AURIX™ TC33xEXT errata sheet

Marking/Step: (E)ES-AA, AA

10595AERRA

Figure 2 CAN Frame with DLC > 4

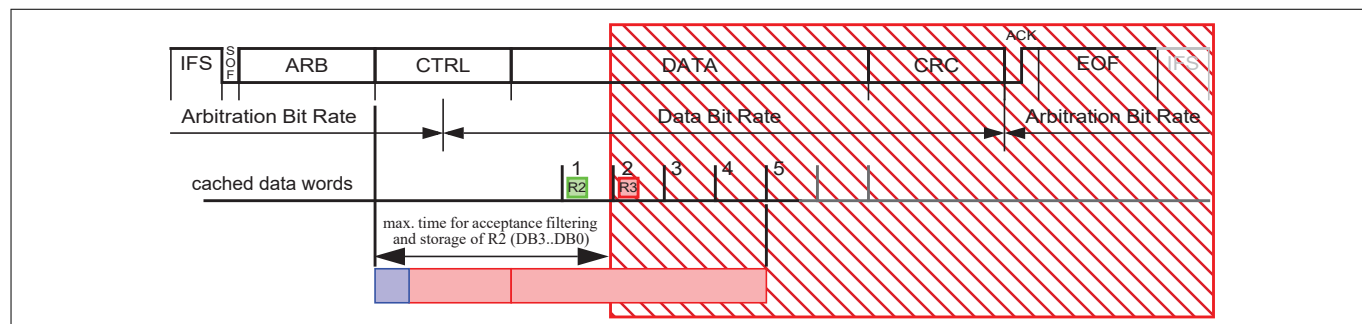
The issue may occur in FD Frame Format as well as in Classic Frame Format.

The figure that follows shows how the available time for acceptance filtering and storage is reduced.

Figure 3 Positive overload on P-pad of a LVDS RX pin pair (both used as inputs)

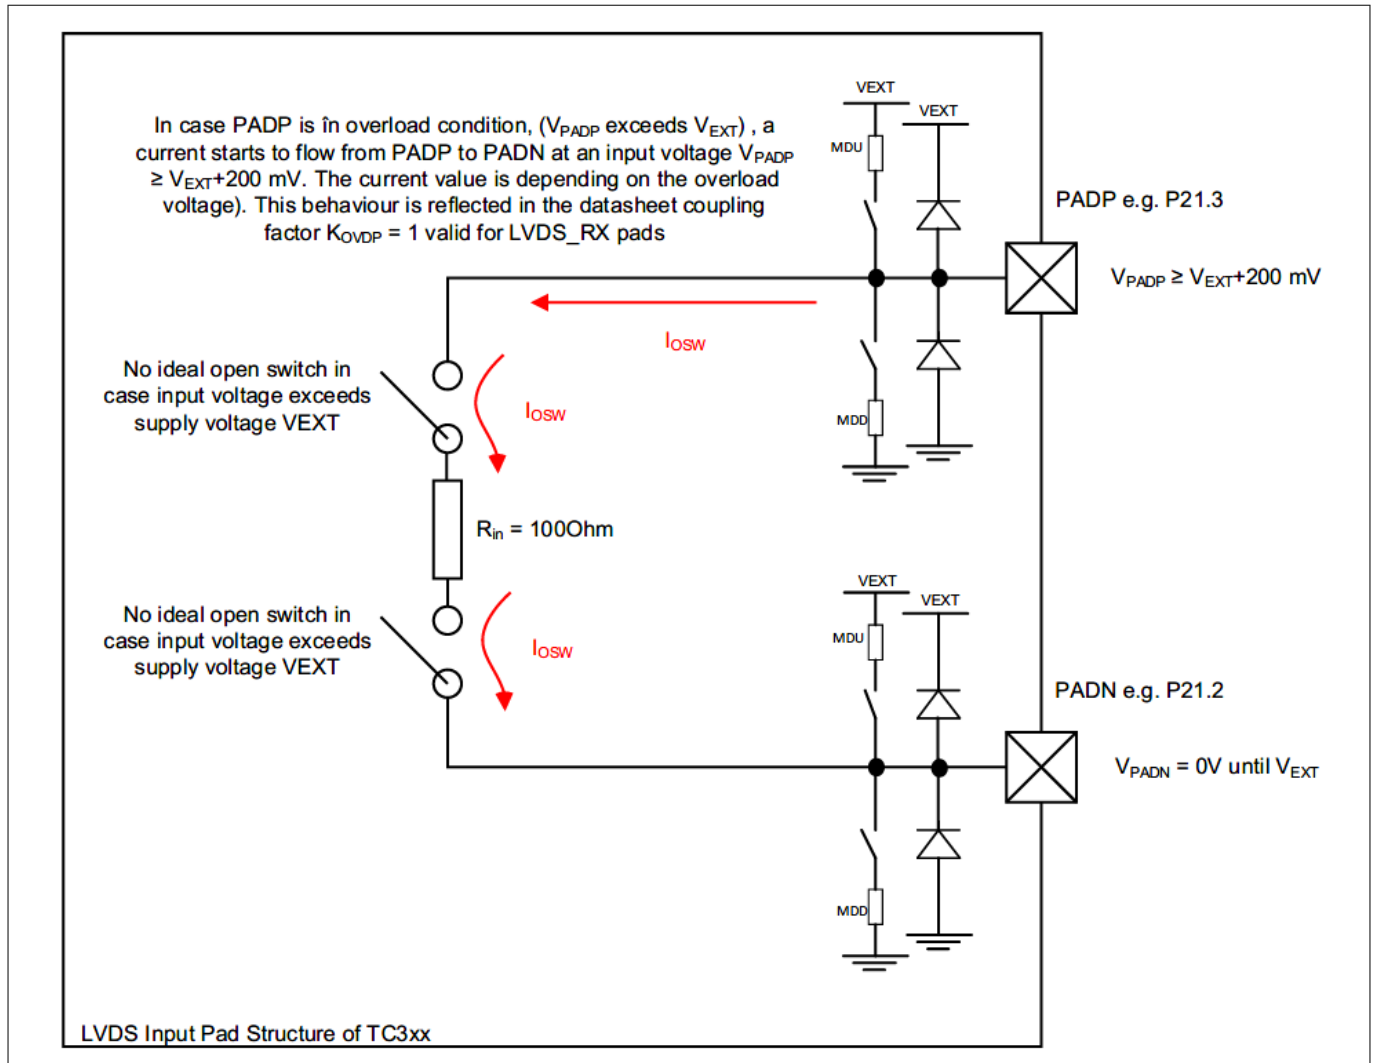
The overload current I_{OSW} through the non-ideal open switch significantly increases when $V_{PADP} \geq V_{EXT} + 200 \text{ mV}$.

Note: In general, the effect will also occur if the N-pad is used as output, or for a negative overload condition on either the P-pad or the N-pad.
